City of Mississauga Department Comments

Date Finalized: 2023-08-09 File(s): A765.22

The applicant requests the Committee to approve a minor variance to allow an existing driveway with a width of 9.50m (approx. 31.17ft) whereas By-law 0225-2007, as amended, permits a maximum driveway width of 5.76m (approx. 18.90ft) in this instance.

Property Address: 3620 Fortune Place

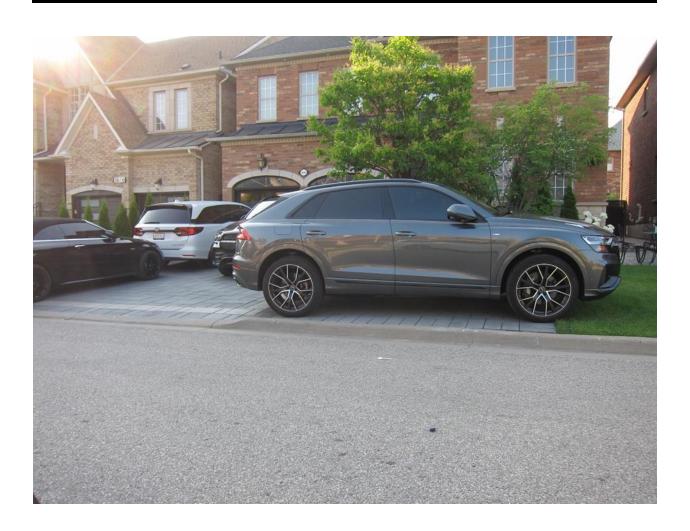
Enclosed you will find pictures of the existing driveway. We cannot support the hard surface that has been created within the Municipal boulevard on the right side of the driveway where the dark grey Audi SUV is parked parallel to the road. This area must be reinstated to its previous sod condition.
